Project Name: Pheasant Run, Spring Valley – Filing #6

Re: File # 96-78 Pheasant Run, Spring Valley Filing #6

REVIEW SHEET SUMMARY

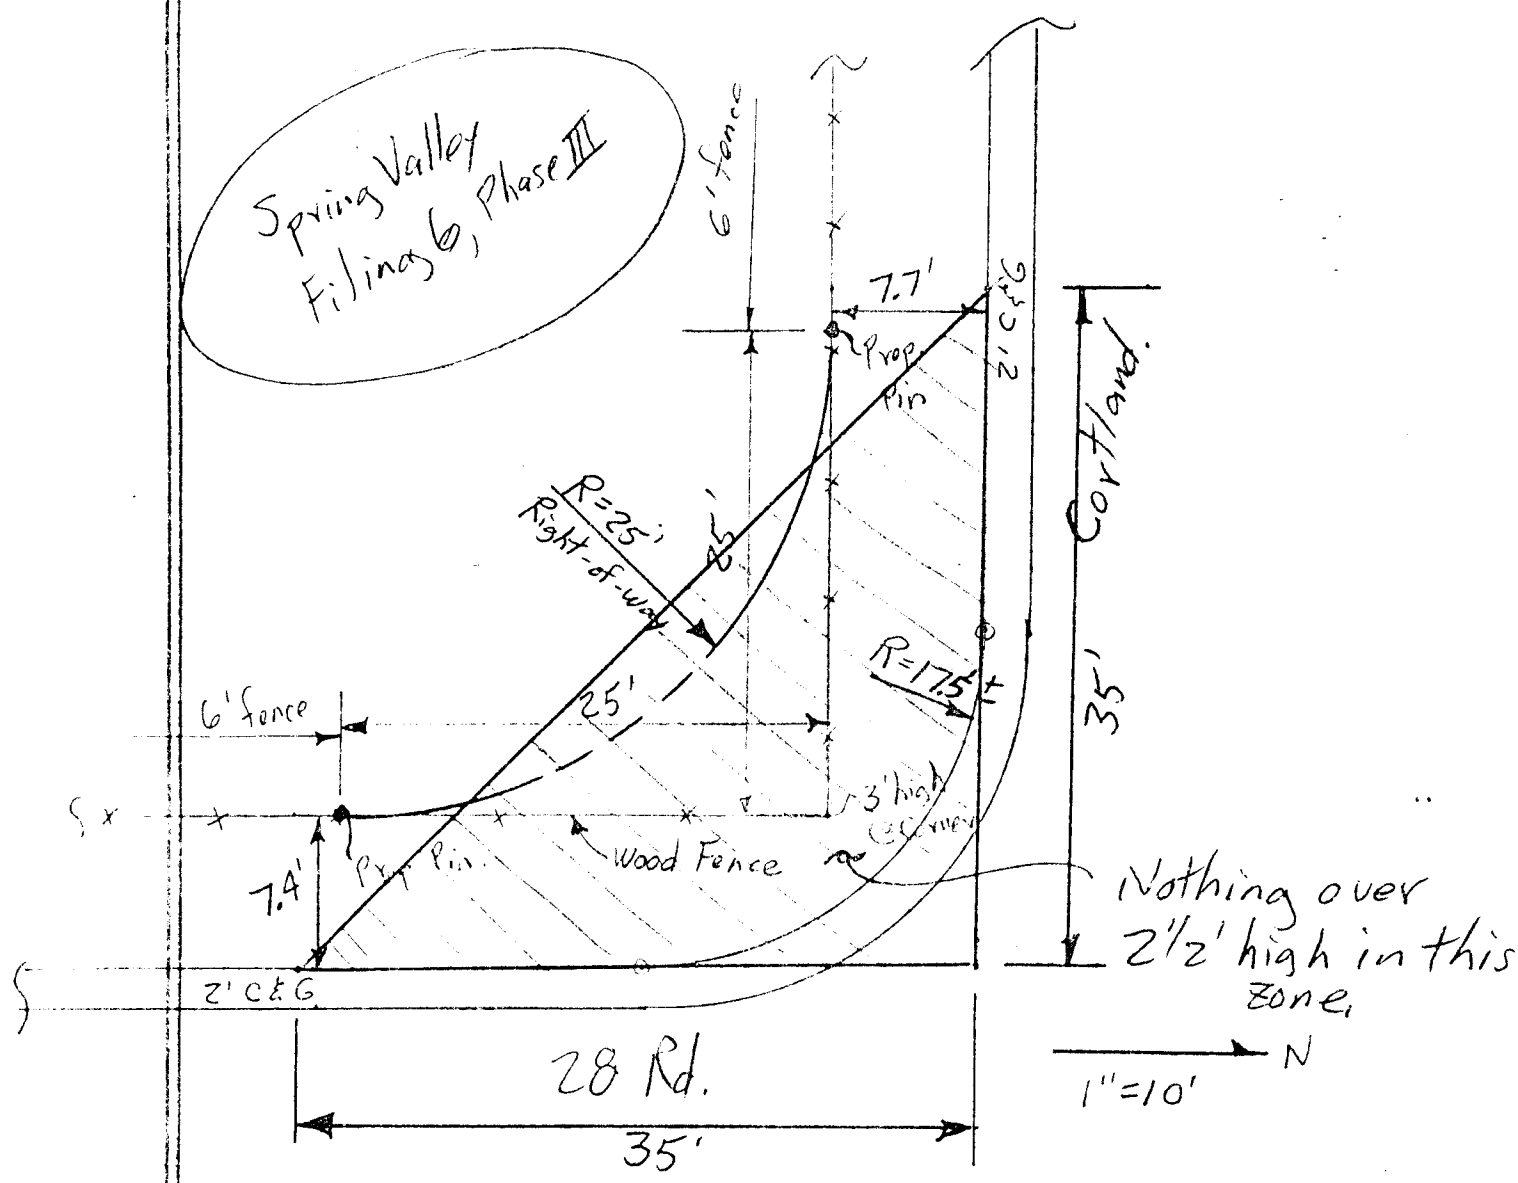
Also enclosed are two (2) copies of fence details included on Paragon's plans for the subdivision improvements which I approved for construction on June 6, 1979. Those details show the barrier fence to be located at 6 ft outside of the street right of way line. It appears the fence has instead been constructed around the entire Spring Valley Subdivision on the right of way line. I do not understand why the approved plans have not been followed.

I am by copy of this letter notifying the Development Department and the subdivision developer, Steve Heald, of these matters. I would advise that you contact them and request that you or Steve advise me in writing of what actions are intended in light of the above.

# PRELIMINARY PLAN FOR: **PHEASANT RUN AT SPRING VALLEY**

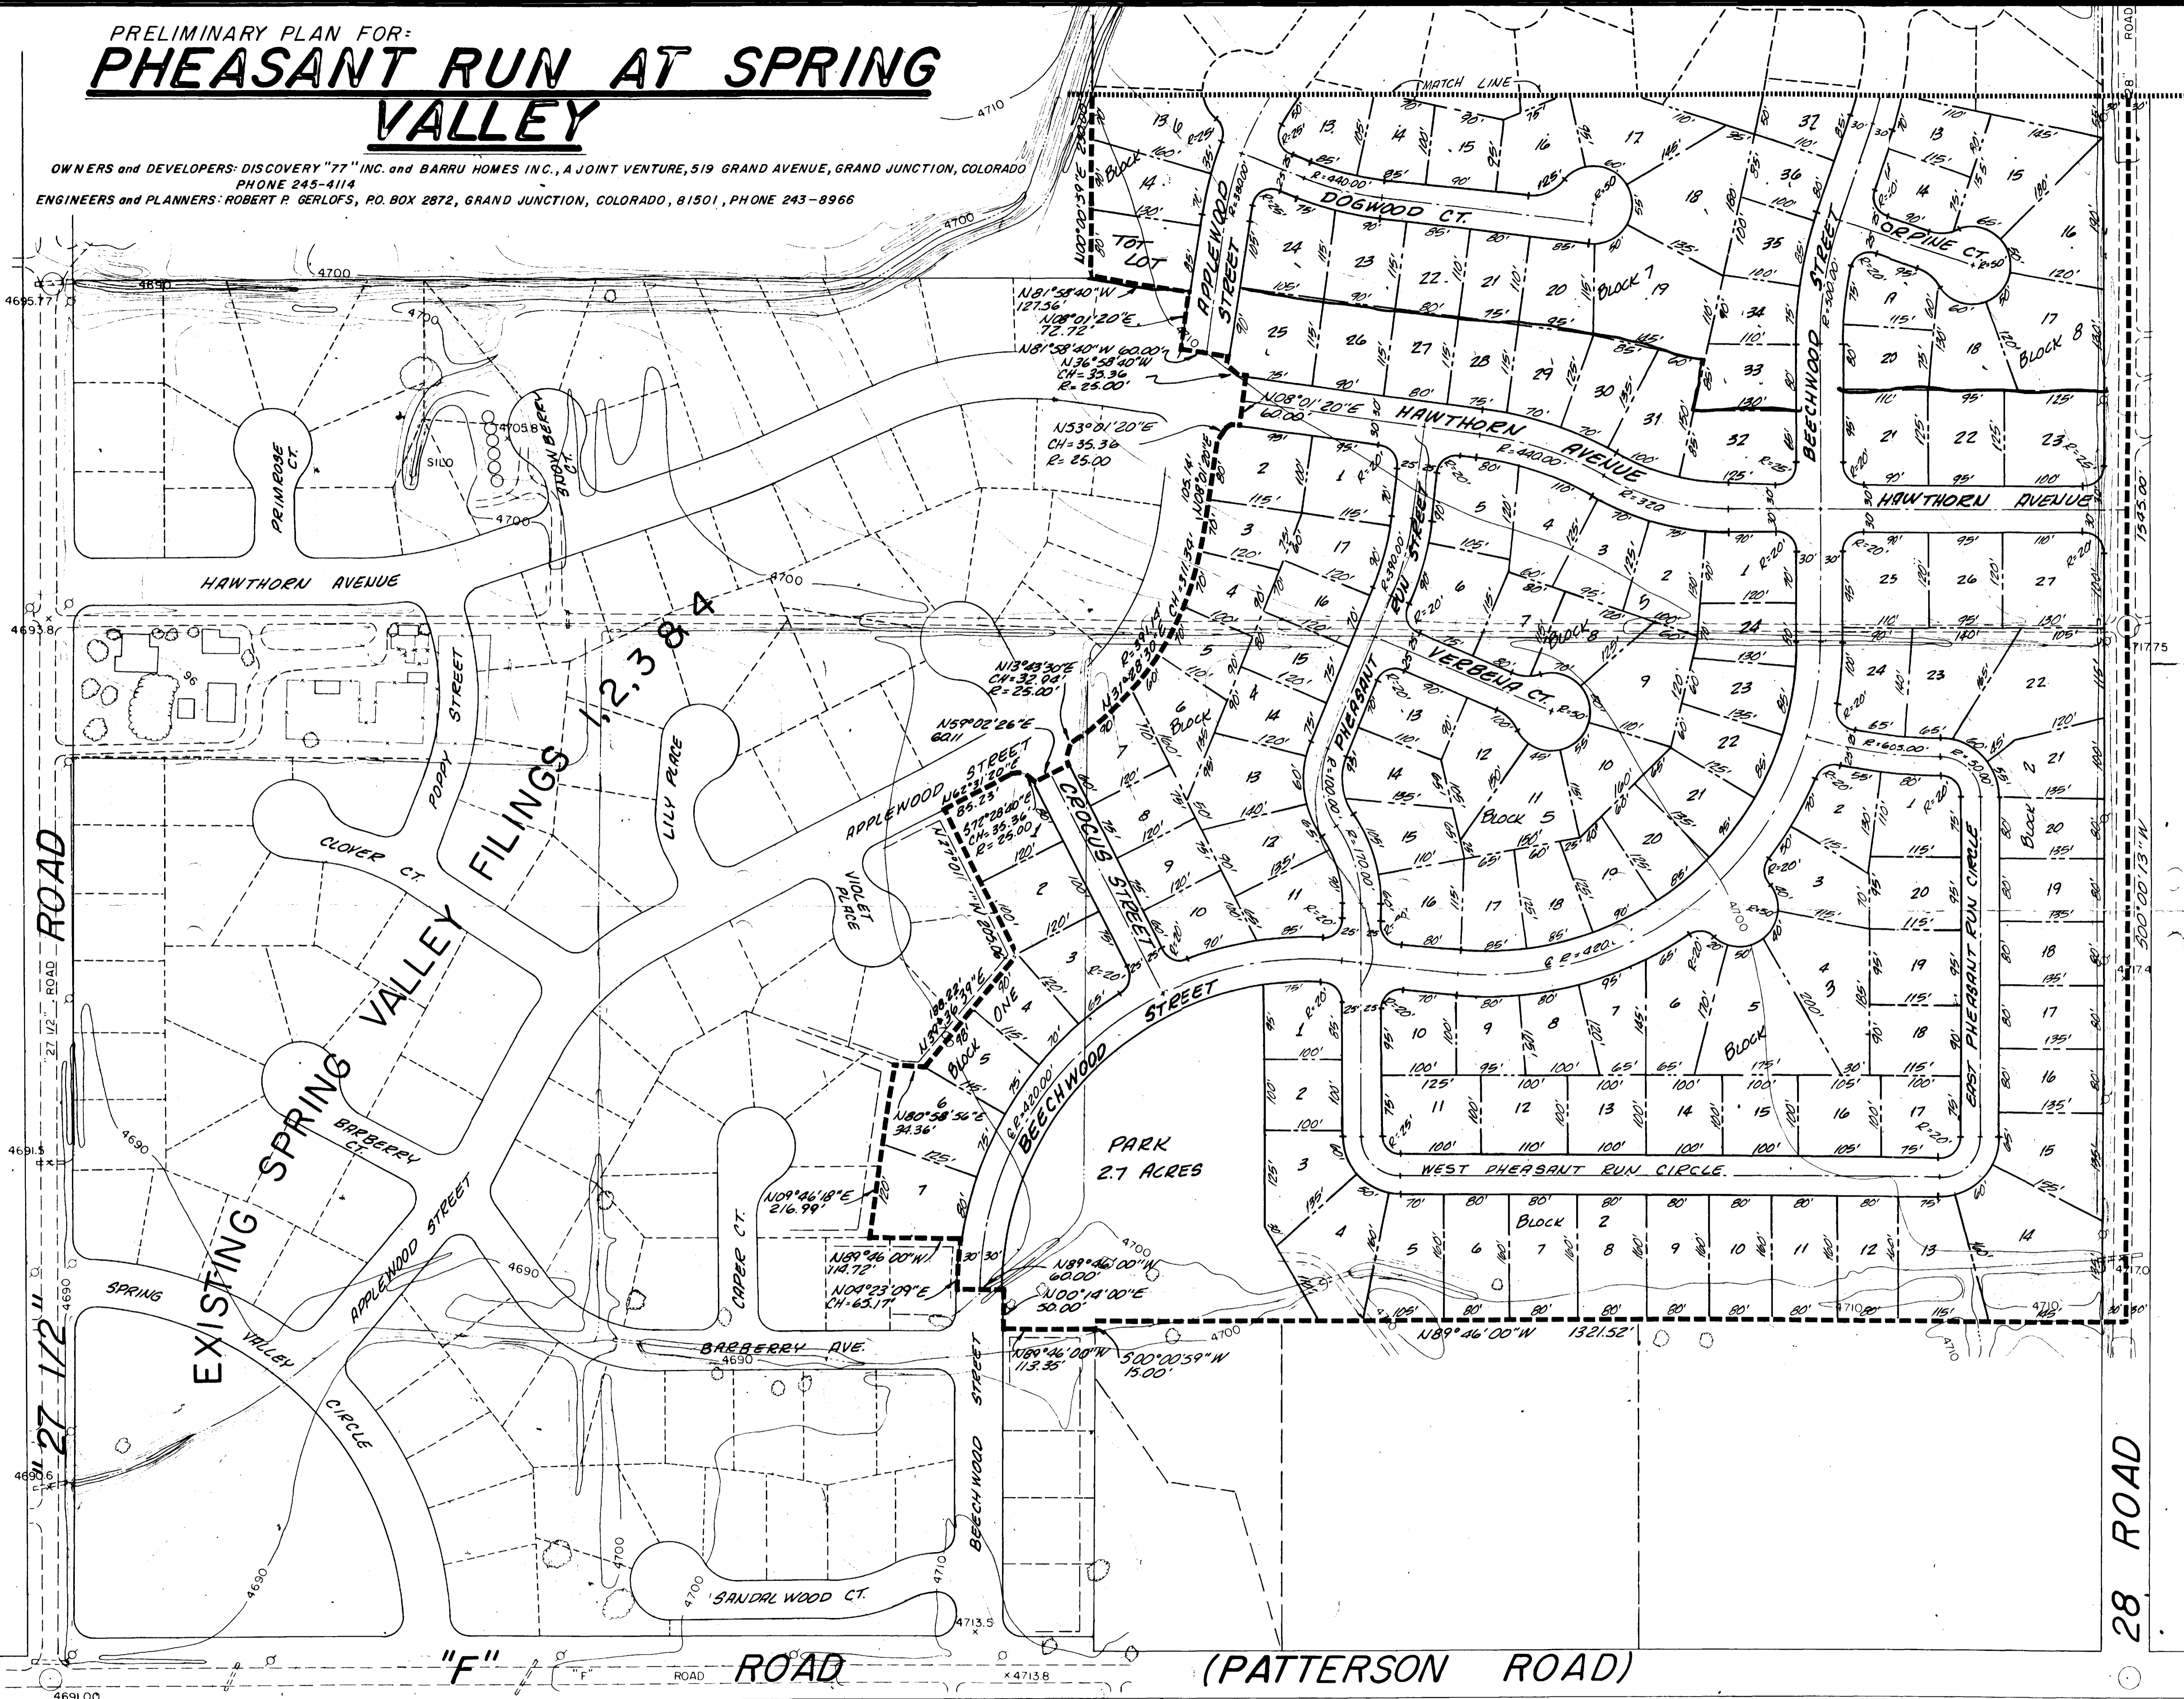
Police Department - Vandertook (Captain Burg)  
Street widths are too narrow. Will cause traffic enforcement problems. Deviated from preliminary greatly. Streets must be wider to facilitate both side parking, two way traffic & sufficient room for emergency & service vehicles. Do not recommend acceptance of this plan.

City Utilities - McGregor  
Change Wintergreen Drive to anything else. You have Wintergreen Ct. & Ave. in your previously approved Wintergreen Estates.

City Fire - Mantlo  
(1) Check street width. (2) Check fire hydrant locations. Item #1. (22 feet plus parking)  
Item #2. The water system plan as shown on the Utilities Composite is approved provided it can supply 2000 GPM from any two of the most hydraulically remote hydrants.  
Attn: Paul Barru and Paragon Engineering: Certain hydrants may be eliminated provided others are moved to compensate - See attached schedule.
